**North Yorkshire County Council**

**National Productivity Investment Fund (NPIF) Otley Road Phase 2 Cycle Route  
Consultation Outcome**

**Report of the Assistant Director – Highways and Transportation**

WEST HARROGATE SCHEMES PHASE 2					
OPTION 1: THE EXISTING PROPOSAL ON OTLEY ROAD FOR PHASE 2 SHEET 2 OF 2					
SCALE:	1:200	DATE:	08/11/2021		
PROJECT NO:	70043022	DATE:	08/11/2021		
PROJECT NO:	70043022-WSP-GEN-WHS-DR-CH-0002	DATE:	08/11/2021	REV:	PD1
© WSP UK Ltd

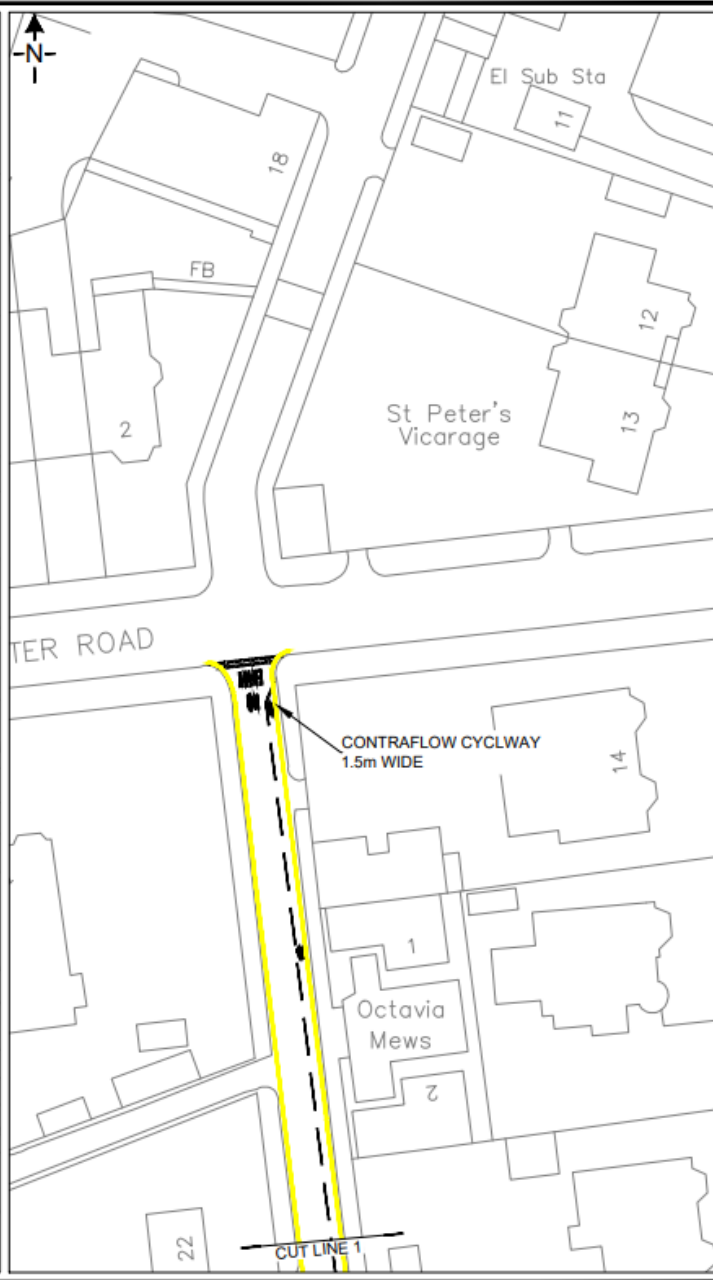
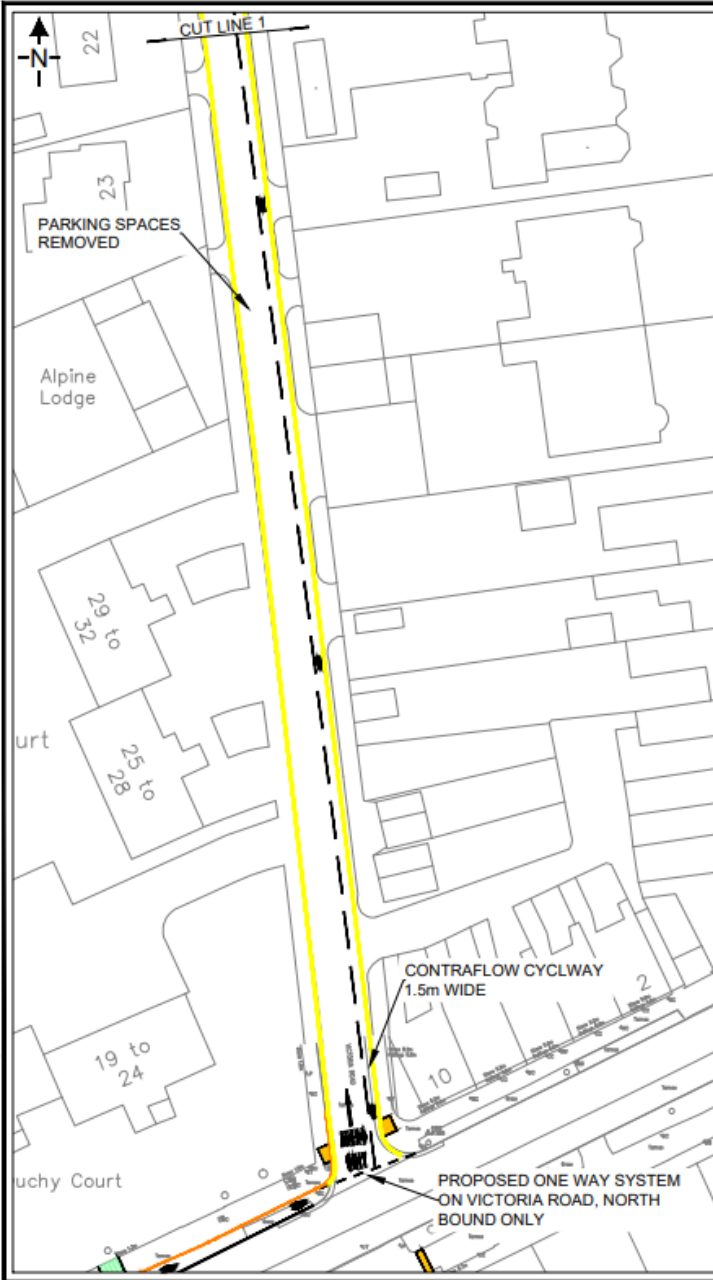
1/2	4		Cyclist	<ul style="list-style-type: none"> <li>• I do not support BG 2), which would have no benefit for walking or cycling.</li> <li>• For NPIF I support 1) as modified by 2) (reaching Beech Grove via Victoria Road and Lancaster Road), but I would like there to be a parallel crossing of Otley Road near its junction with Beech Grove, to enable the safe crossing of a very busy road, and priority cycle crossings of the mouths of Park Avenue and West End Avenue.</li> <li>• I do not support Option 3 (Queens Road).</li> </ul>	25/10/2022
1/2	4	Bilton Lane	Cyclist	<ul style="list-style-type: none"> <li>• I do not support BG 2), which would have no benefit for walking or cycling.</li> <li>• For NPIF, I support 1) as modified by 2) (reaching Beech Grove via Victoria Road and Lancaster Road), but I would like there to be a parallel crossing of Otley Road near its junction with Beech Grove, and priority cycle crossings of the mouths of Park Avenue and West End Avenue.</li> <li>• I do not support Option 3 (Queens Road).</li> </ul>	25/10/2022

1	5		<ul style="list-style-type: none"> <li>• The Queen's Road option is insane. Unless you plan on getting rid of the hospital.</li> <li>• Those model blockages were a disgrace. Do not think of bringing them back. Everyone was happy when you finally got rid of them. Stop pandering to rich people on Beech Grove.</li> <li>•</li> </ul>	27/10/2022
1/2	4		<ul style="list-style-type: none"> <li>• I do not support BG 2), which would have no benefit for walking or cycling.</li> <li>• For NPIF, I support 1) as modified by 2) (reaching Beech Grove via Victoria Road and Lancaster Road), but I would like there to be a parallel crossing of Otley Road near its junction with Beech Grove, and priority cycle crossings of the mouths of Park Avenue and West End Avenue.</li> <li>• I do not support Option 3 (Queens Road) mainly because it uses shared footway for cyclists and pedestrians.</li> <li>•</li> </ul>	25/10/2022

TITLE: OPTION 3: AN ALTERNATIVE ROUTE FOR PHASE 2 USING QUEENS ROAD

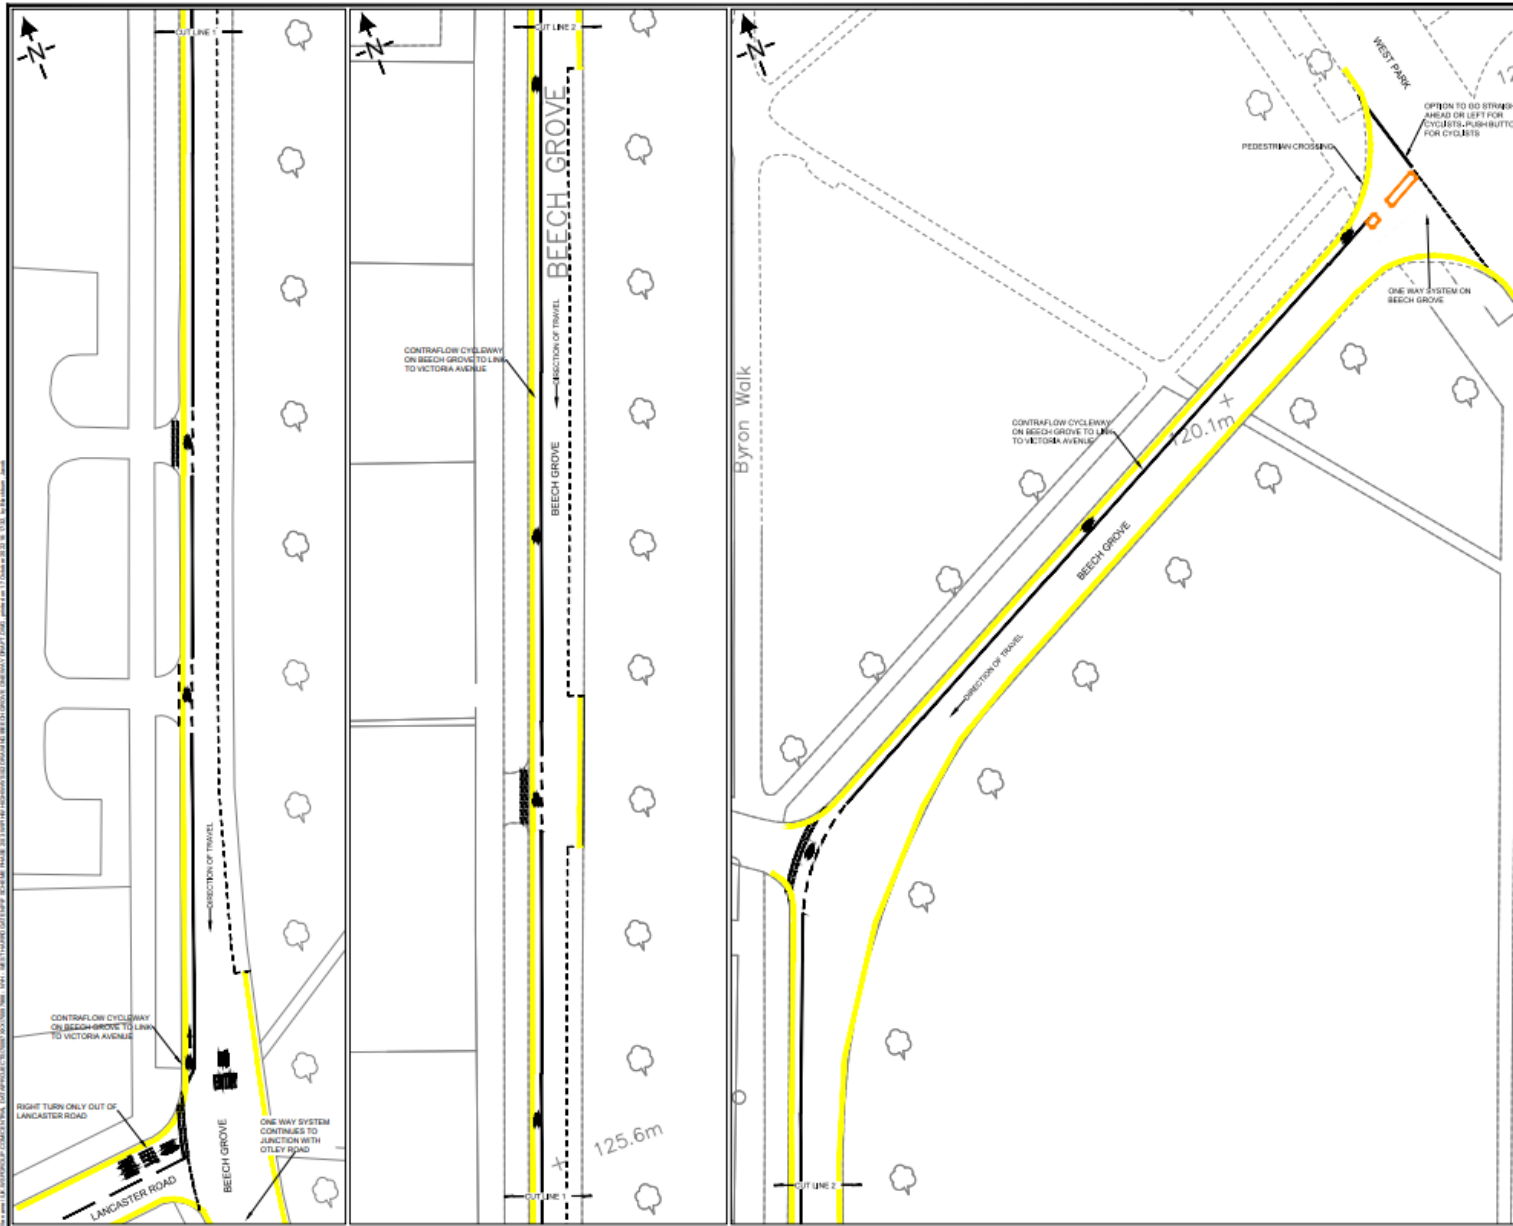
3	5			<p>The narrow shared footway and cycleway is dangerous and its only a matter of time before there is a serious accident or event a death. Therefore, the Queens road option is by far the safest, because it reduces the time pedestrians and cyclists spend together on the most dangerous section. A bicycle is a vehicle, after all, according to the revised Highway code, and it is important that pedestrians and vehicles are segregated for the safety of pedestrians. For example, pedestrians have pavements and vehicles have roads. An average of 4 pedestrians per year have been killed by cyclists, and an average of 137 seriously injured since 2013, despite them being segregated - the less that these two groups have to share the same pavement area, the lower the risk of death and injury.</p>	11/07/2022
2/3	4			<p>The plans were blurred and very difficult to understand. Poor consultation techniques.</p>	11/07/2022

3. Given that this route will be a repetition of Phase 1 with a substantial degree of sharing between cyclists and pedestrians, then it does not provide a feasible option. It will also take people away from Beech Grove. There appears to be no merit whatsoever with this option.
